FIELD INSPECTION

Project Name:	Mountain Valley Pipeline	Inspector:	Marshall Willis
Inspection Date:	Friday, February 22, 2019	Project Contact:	Brian Clauto
Spread I: Franklin County Pittsylvania County	STA 14981+55 – 14950+47 STA 14981+55 – 15028+09	Weather (Wet/Dry/Rain):	Rainy

FIELD INSPECTION PHOTO LOG

Fig. 1: **STA 14968+00** – Undermined CFS.

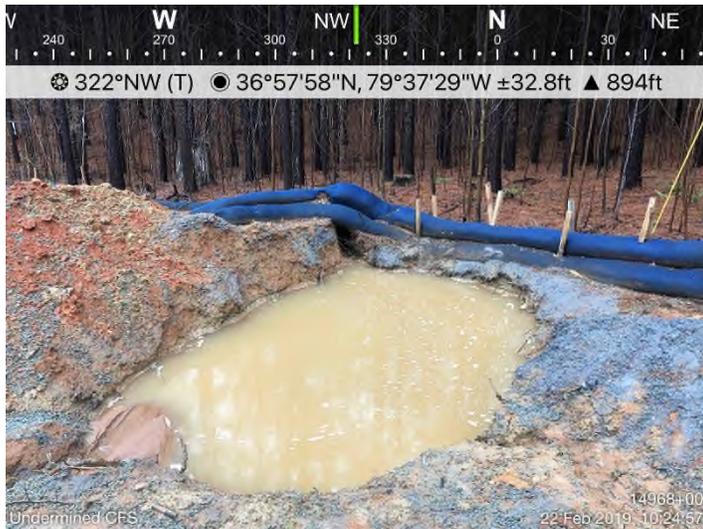
- Streams / wetlands inspected included: S-G13, W-MM17, S-D7, S-D3 and S-D4.
- Undermined CFS at STA 14968+00.
- CFS needs maintenance at STA 14953+00.
- CFS needs maintenance at STA 14975+00.
- Erosion fabric needs maintenance at STA 14975+00.
- Inadequate stabilization around MLV 33 at STA 14979+85.
- CFS needs maintenance at STA 14983+20.
- CFS needs maintenance at STA 14983+20.
- CFS needs maintenance at STA 14986+00.

Recommended Corrective Action: Maintain and install all controls per the approved plan and specs.
